Re: Fuel Leak Case No. RO000212  
Holland Oil  
16301 East 14<sup>th</sup> Street  
San Leandro, California

### **WORKPLAN ADDENDUM**

**Response to technical comments regarding the document entitled “Work Plan: Additional Subsurface Investigation Groundwater Monitoring Well Installation” dated March 3, 2003, by Environmental Bio-Systems, Inc., Mill Valley, California.**

This Workplan Addendum was prepared in response to comments from Alameda County Health Care Services, Environmental Health Services (ACEH), in a letter dated October 23, 2005.

<b>SITE LOCATION MAP</b> Holland Oil 16301 E. 14th Street San Leandro, California	<b>CLEARWATER GROUP</b>		
	Project No. <b>CB015D</b>	Figure Date <b>04/06</b>	Figure <b>1</b>

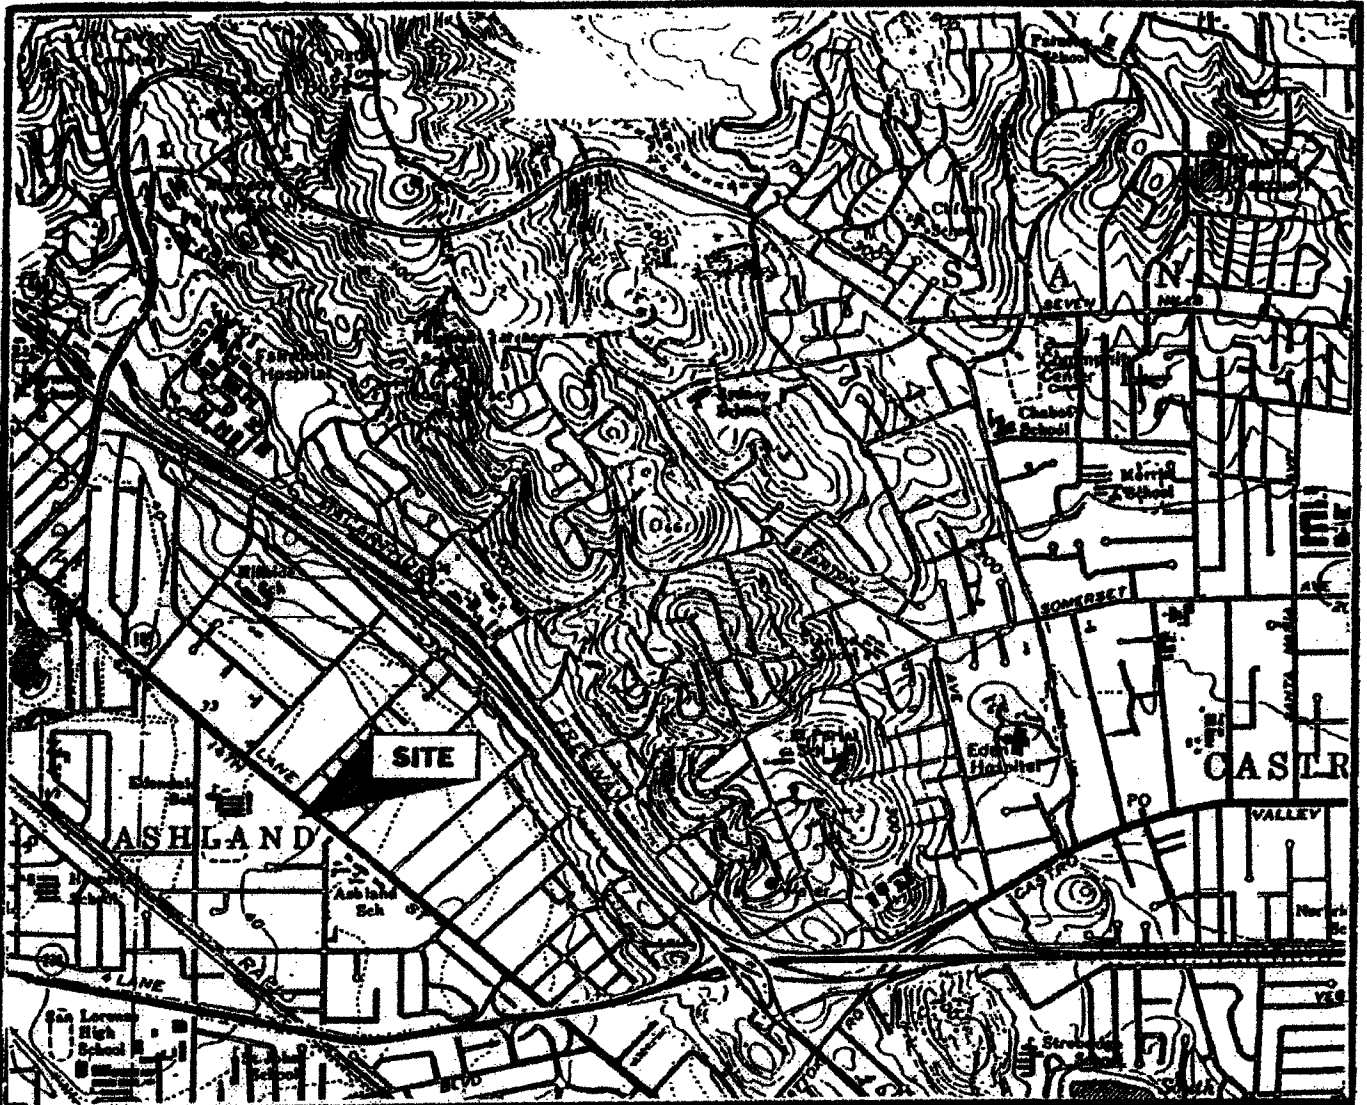
#### **Comment 1: Proposed Soil Borings**

Clearwater Group (Clearwater) will drill three additional direct push soil borings (SC58 through SC60) to 12 feet below ground surface (bgs) to collect soil and groundwater samples along the western edge of the property (Figures 1 and 2). The additional borings and previously proposed borings SC55, SC50, SC54 and SC52, will be used to create a transect near the western property edge to assess whether shallow groundwater contamination is moving offsite. The additional borings will be between borings SC54 and SC50, between SC50 and SC55, and one location south of SC55.
